SUNDRY NOTICES AND REPORTS ON WELLS (DO NOT USE THIS FORM FOR PROPOSALS TO DRILL OR TO DEEPEN OR PLUG BACK TO A DIFFERENT RESERVOIR. USE "APPLICATION FOR PERMIT" (FORM C-101) FOR SUCH PROPOSALS.)		WELL API NO. 30-025-25779
1. Type of Well: Oil Well ☒ Gas Well ☐ Other ☐		5. Indicate Type of Lease STATE ☒ FEE ☐
2. Name of Operator Matador Production Company		6. State Oil & Gas Lease No.
3. Address of Operator 5400 LBJ Freeway STE 1500 Dallas, TX 75240		7. Lease Name or Unit Agreement Name Northeast Kemnitz Unit
4. Well Location Unit Letter F : 1980 feet from the North line and 1980 feet from the West line Section 16 16S Township 34E Range NMPM LEA County		8. Well Number 003
11. Elevation (Show whether DR, RKB, RT, GR, etc.) 4117'		9. OGRID Number 228937
10. Pool name or Wildcat KEMNITZ; LOWER WOLFCAMP

Matador is requesting to plug and abandon the Northeast Kemnitz #3, per the required COA, following the procedure below:

Northeast Kemnitz #3
 1980' FNL & 1980' FWL Sec 16 - 16S - 34E
 Lea County, NM
 API: 30-025-25779
WELLBORE SCHEMATIC
 Spudded: 1/28/1978

**CONDITIONS OF APPROVAL
FOR PLUGGING AND ABANDONMENT
OCD - Southern District**

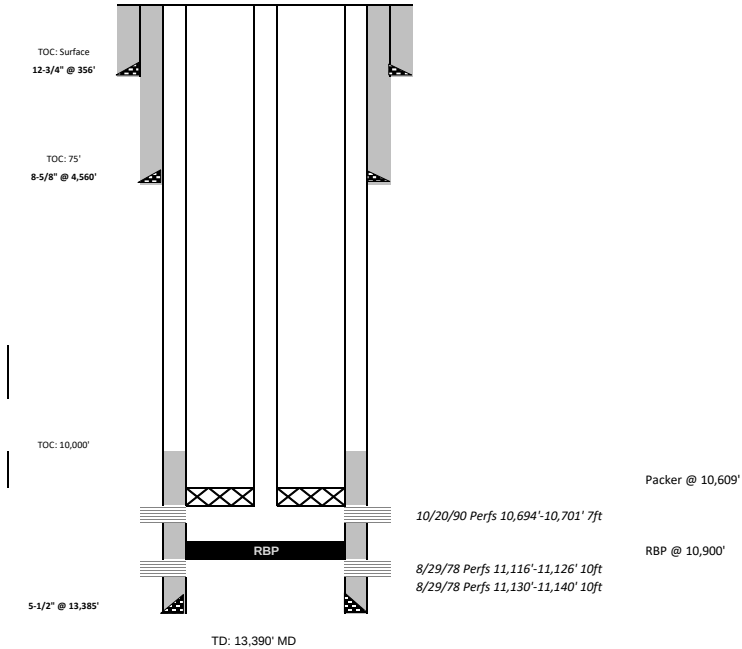
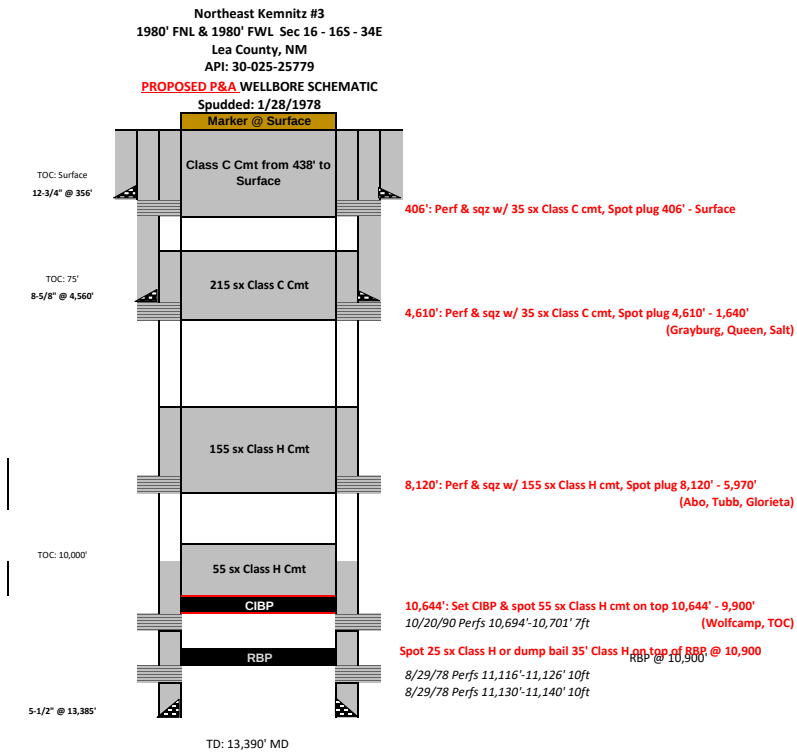
- Notify NMOCD 24 hrs before MIRU.
- Safety mtg, MIRU, check pressures, pull rods and pump.
- ND wellhead, NU BOPs & TOO H w/ tbg. **Spot 25 sx Class H or dump bail 35' Class H on top of RBP @ 10,900**
- RU WL. WL set CIBP @ 10,644'. RD WL. TIH w/ tbg and spot 55 sx Cl H cmt on top of CIBP. WOC & Tag. (Isolate Wolfcamp and TOC)
- Circ and displace hole w/ MLF.
- Perf @ 8,120' & sqz Cl H cmt. Spot from 8,120' – 5,970'. WOC & Tag. (Isolate Abo, Tubb, Glorieta)
- Perf @ 4,610' & sqz Cl C cmt. Spot from 4,610' – 1,640'. WOC & Tag. (Isolate Grayburg, Queen, and Salt)
- Perf @ 406' & sqz Cl C cmt to surface.
- Cut off wellhead and ensure cmt to surface on all csg strings.
- Install above ground marker per NMOCD specifications.

NOTE CHANGES TO PROCEDURE
